Annex N Updates

Lily Lyu

March Plenary

Update of 36.1.1

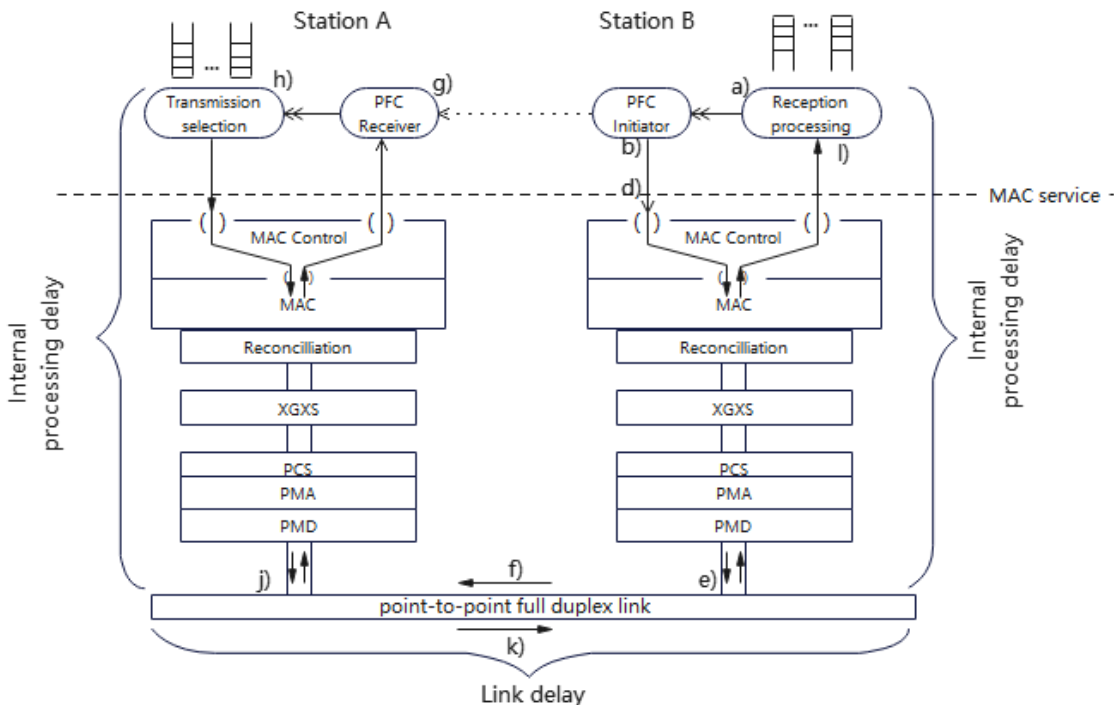
PFC frame transmission in PFC initiator station B:

- a) B's reception processing to calculate the remaining buffering following frame receipt.
- b) B's PFC Initiator to initiate PFC following that buffering calculation and PFC frame encoded ready for transmission.
- c) Any prior in-progress frame transmission by B (possibly of a maximum sized frame) to complete.
- d) First bit of PFC frame sent to MAC service.
- e) Last bit of PFC frame sent on the physical link.

PFC frame transmission across link from B to A:

- f) The link delay for transmission from B to A.

PFC frame reception in PFC receiver station A (including PFC taking action):

- g) PFC frame reception since the last bit of PFC frame received on link, including frame validation, by A's interface stack.
- h) A's PFC Receiver to decode the PFC frame and halt transmission selection for specified priorities.

User data transmission in PFC receiver station A:

- i) Any in-progress frame transmission by A (possibly of a maximum sized frame) to complete.
- j) Last bit of last frame sent on the physical link.

- k) The link delay for transmission from A to B.

User data reception in PFC initiator station A:

- l) Reception delays associated with B's interface stack, reception processing, and buffering.

N.2 Delay model of PFC headroom

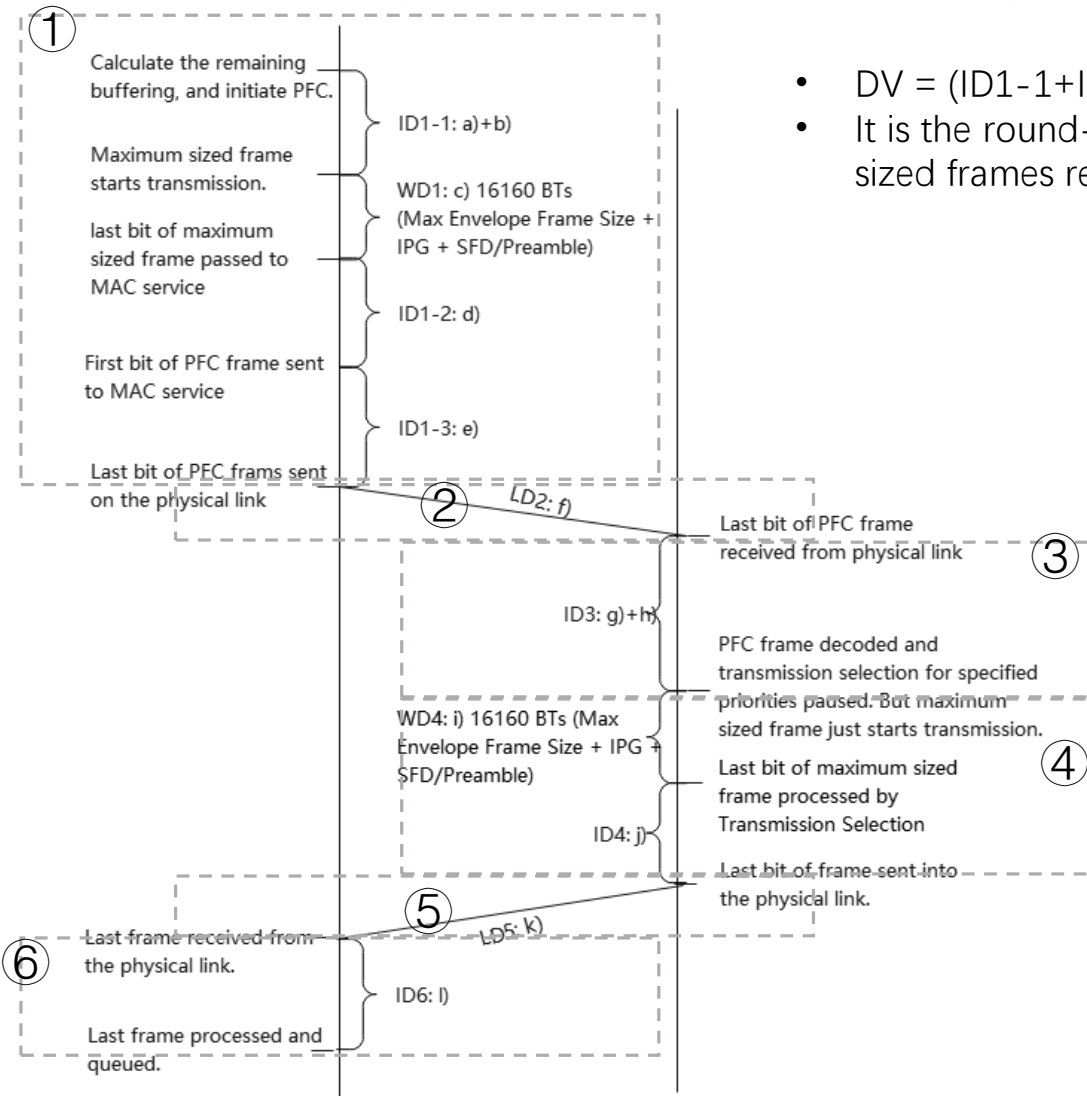
Figure shows a possible worst-case delay example where MACsec is disabled for PFC frame and user data.

- $DV = (ID1-1+ID1-2+ID1-3) + WD1 + LD2 + ID3 + WD4 + ID4 + LD5 + ID6$
- It is the round-trip delay from PFC initiation to last frame reception and buffered, plus 2 maximum sized frames represented by bit times.

MACsec supported (data frame):

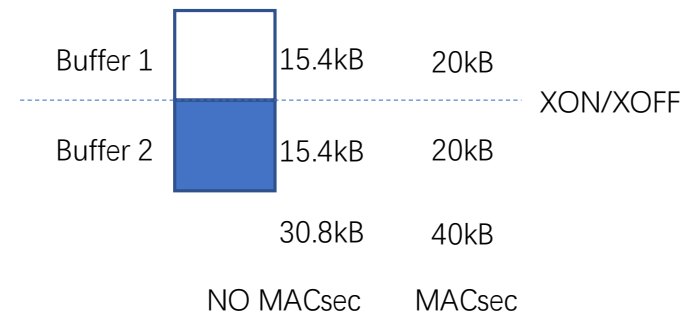
WD1 and ID4, each is incremented by 19 360 bit times

$$DV = 126\ 224 + 19\ 360 + 19\ 360 = 164\ 944 \text{ bit times}$$

---> **PFC headroom is 20kB**
